Independent Review Tillegra Dam: Project Justification

Project Name:	Independent Review Tillegra Dam : Project Justification
Project Number:	3001815
Report for:	NSW Department of Planning

INDEPENDENT REVIEW TILLEGRA DAM : PROJECT JUSTIFICATION

Questions and Answers – SMEC and DoP review of “Project Justification” aspects of EAR

Figure 6: Simulated Tillegra Storage Volumes

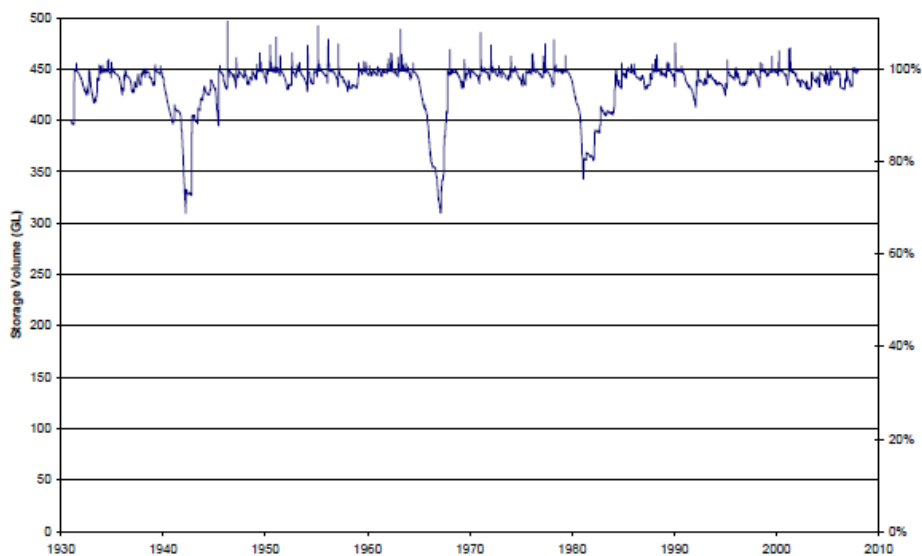
1. *Section 3.7 of the Bewsher Report provides simulated storage levels of Tillegra Dam and shows the dam will be more than 90% full for 90% of the time. Please comment on the need for the dam as over the 77 year historical period of record that the Bewsher Report has plotted, there are three events where there are drawdowns to about 70% full, otherwise the dam is almost 100% full for the remainder of the time. Please comment on the justification and size of the dam given this data.*

1. The figure below is extracted from Section 3.7 of the Bewsher report and purports to show the simulated storage volumes in the proposed Tillegra Dam for the 77 year historical record with the “ultimate demand” of 120 GL/a. It shows that Tillegra dam is ninety percent full for ninety percent of the time and ninety five percent full for eighty five percent of the time. The Bewsher Report does not make any comment or draw any conclusions in Section 3.7 but in the immediately preceding Section 3.6 of the same report there is a reference to the availability of ‘air space’ to mitigate downstream flooding. It could be inferred that the intention of Section 3.7 of the Bewsher Report may have been the assessment of the availability of ‘air space’ for which a conservative approach is required.

The query above however relates to the necessity of this storage and the size of the storage given that it appears to be full most of the time and is called upon on only three occasions.

The figure shows that under a repetition of the observed inflow record and with the demand at 120 GL/a, the dam will be required only during the droughts of 1942, 1967 and 1980. For the majority of the time that dam will be nearly full.

In conclusion, it is our view that water supply systems dependant on the highly skewed patterns of surface inflows observed in South East Australia; need to be maintained at high levels of ‘fullness’ to ensure that sufficient reserves of water are available to cope with droughts of greater intensity than those observed in the past. Consequently the behaviour pattern of Tillegra dam under historical conditions as shown in the above figure does not necessarily indicate an oversupply of water.

Figure 1 Relationship between Demand and Lead Times in DMP

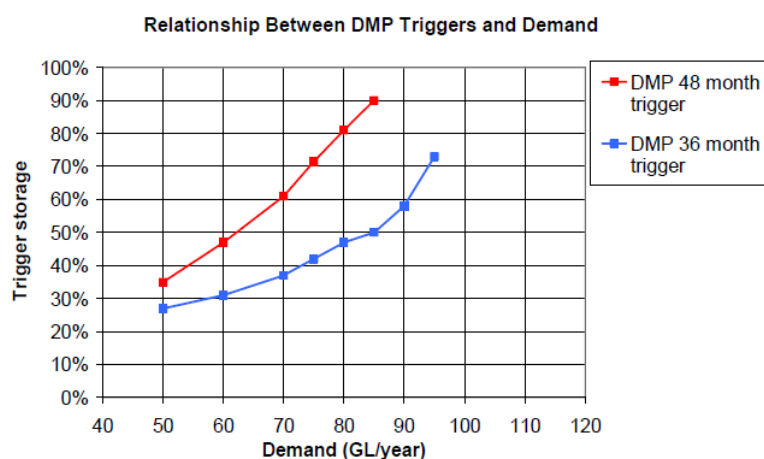
The calculations underpinning this ten percent rise are not clear. Over the period 2009-2012 one could expect an increase in demand of around 2.8 GL/a based on a population increase of 6,400 persons per annum. It needs to be explained as to why this change in demand requires a 10% (27 GL) of storage change to the trigger point.

It would appear that the statement is in error. The following graph shows the relationship between the 48 month trigger and demand that should have been used to inform any such statement:

It can be seen from the above graph that demand would need to grow from 75 to 80GL/year for the 48 month trigger to be pushed up from 70% to 80%. Based on demand increase alone one might expect the trigger storage to be pushed up by a bit under 20GL once restrictions are taken into account (5GL/yr for 4 years). However, given that there are high loss rates when the storages are full, depletion rates are substantially faster than can be accounted for by usage alone, so when the trigger is pushed up, it needs to be pushed further than would initially seem necessary.
